**ADDENDUM #1 – FEBRUARY 9, 2026**  
 REQUEST FOR PROPOSALS  
 FARMLAND WATERWAY RESHAPING & TILING PROJECT

This Addendum is added to and shall become a part of the Request for Proposal (RFP) documents dated February 26, 2026. Proposers shall acknowledge receipt of this Addendum in the Letter of Transmittal. Failure to comply may result in rejection of the Proposal.

ATTACHMENT B – PROJECT AREA

Figure 1: Waterway Widths and Lengths

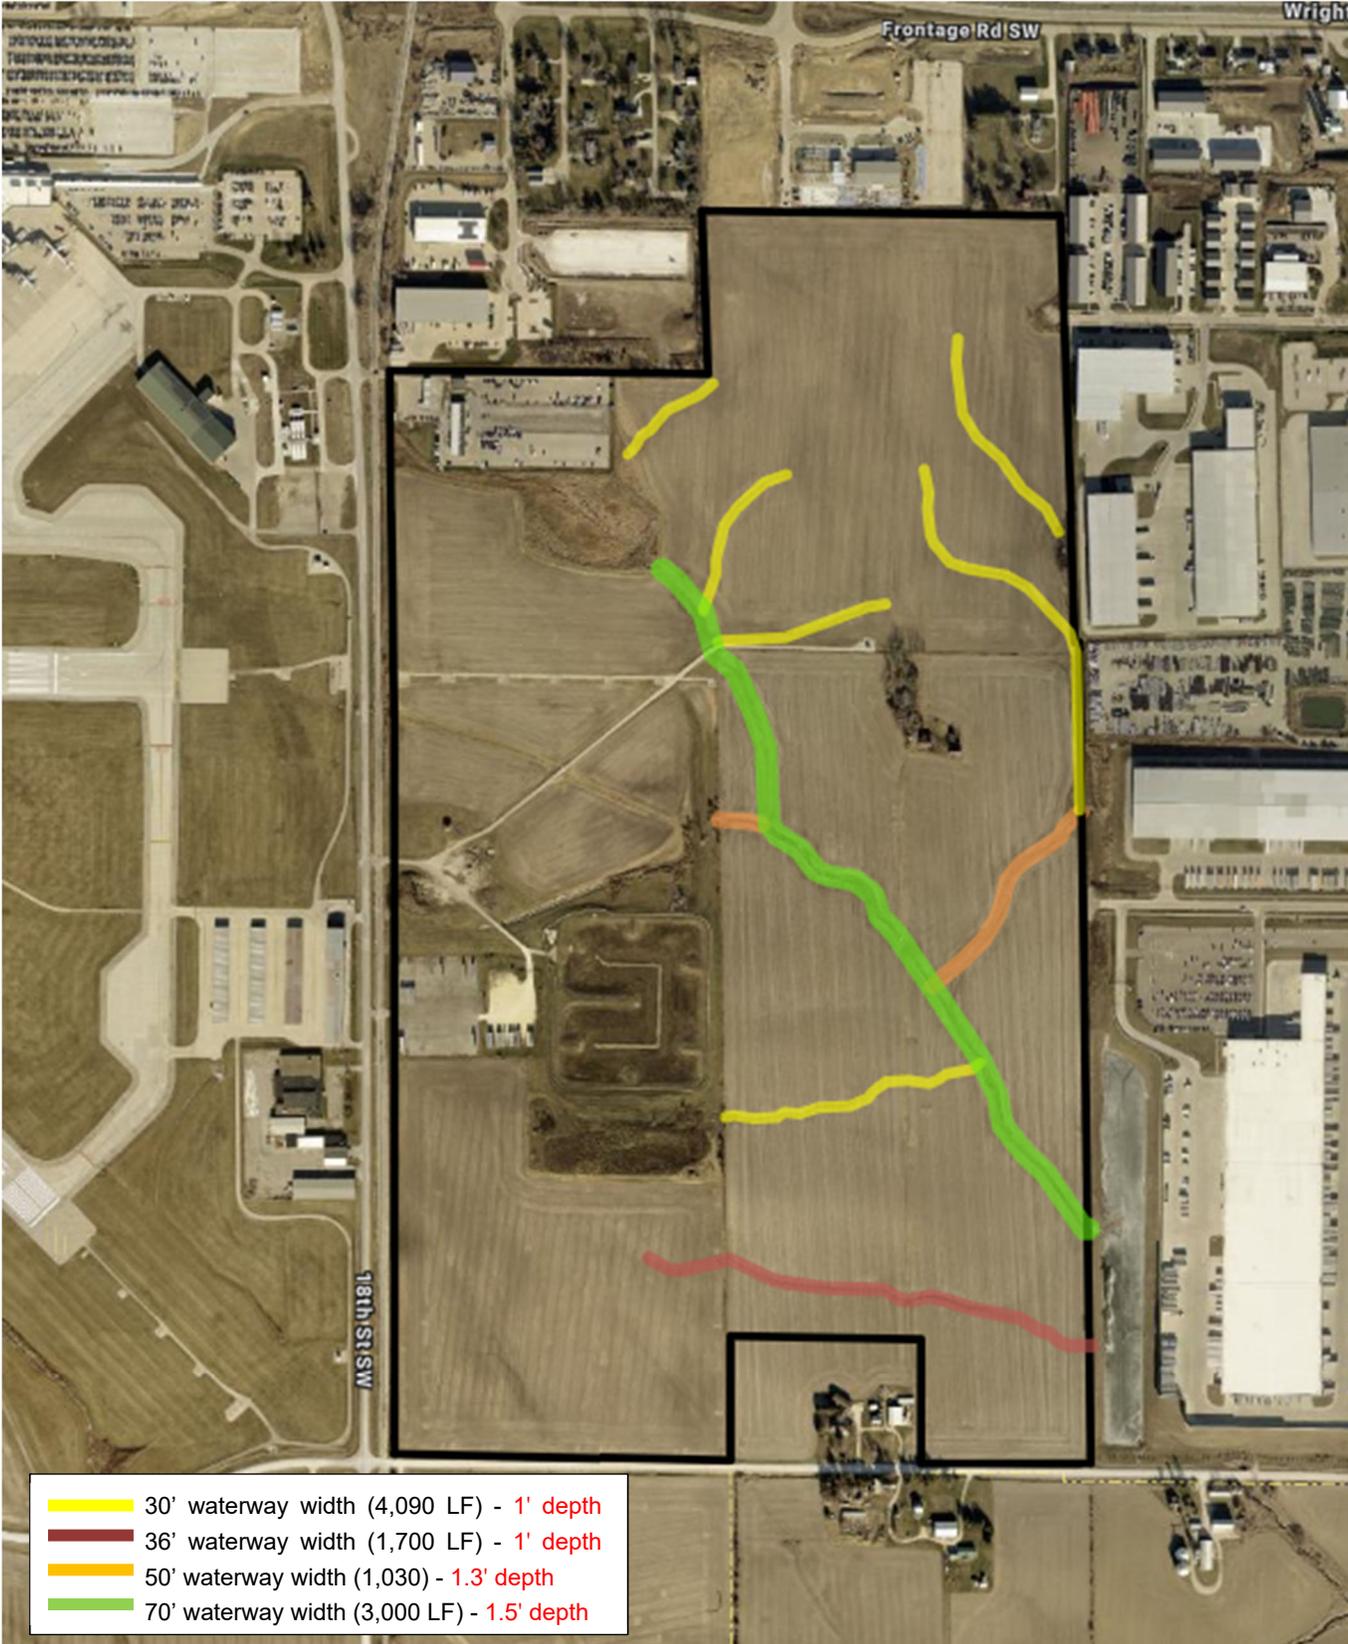
The new Attachment B specifies the depth of cut for the water ways, which are as follows:

- 30' waterway widths – 1' depth
- 36' waterway widths – 1' depth
- 50' waterway width – 1.3' depth
- 70' waterway width – 1.5' depth

Tile should be installed at least 2' **below bottom of finished** waterway.

**Figure 3:** Overall Tiling Plan – No Aerial

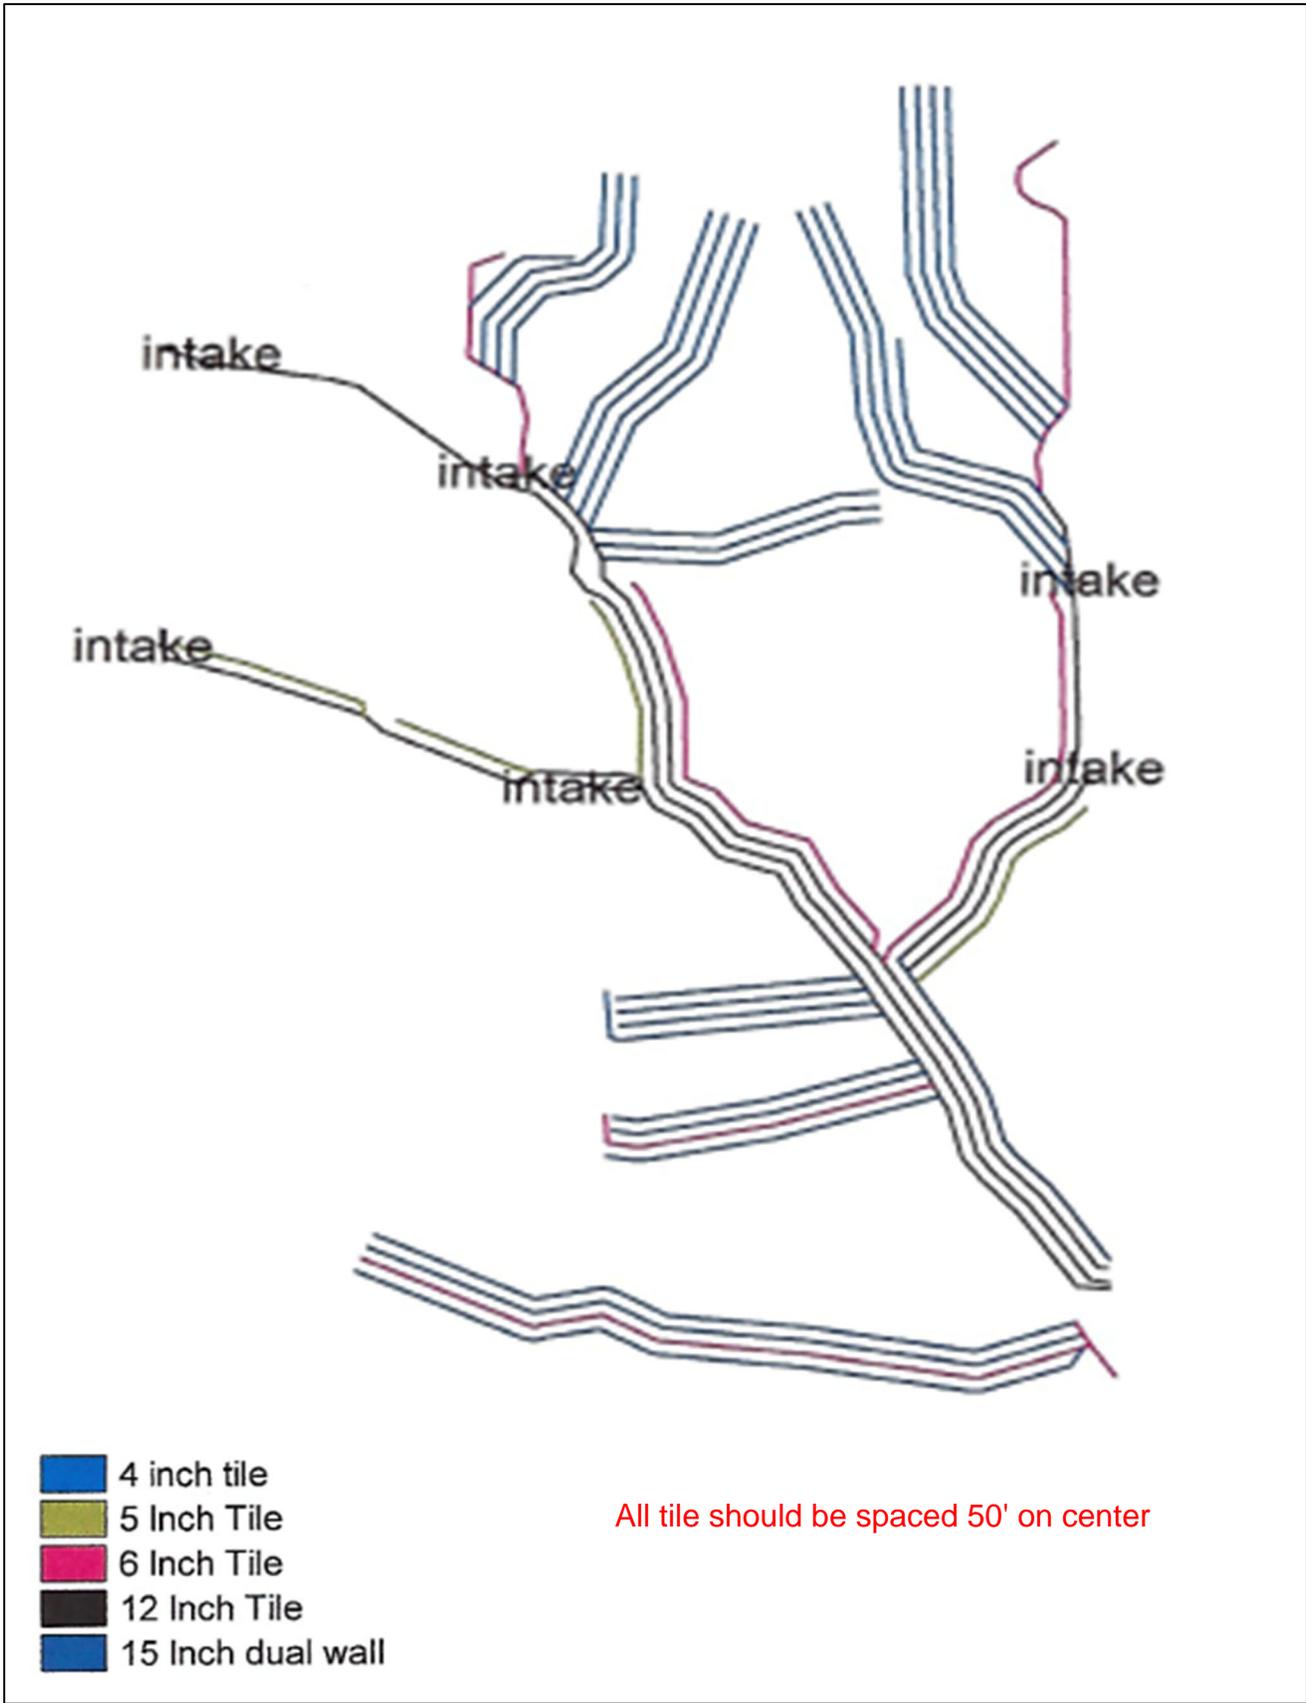
- 1.1. The tile spacing of all lines shall be 50' on center **and at least 4 feet below final grade.**
- 1.2. A new *Attachment B Project Layout* replaces the Attachment B. The new attachment shows the spacing of the tiling on the map. An additional map shows the existing public utilities in the project vicinity.

Note: Tile should be 2' below bottom of waterway

All tile should be spaced 50' on center
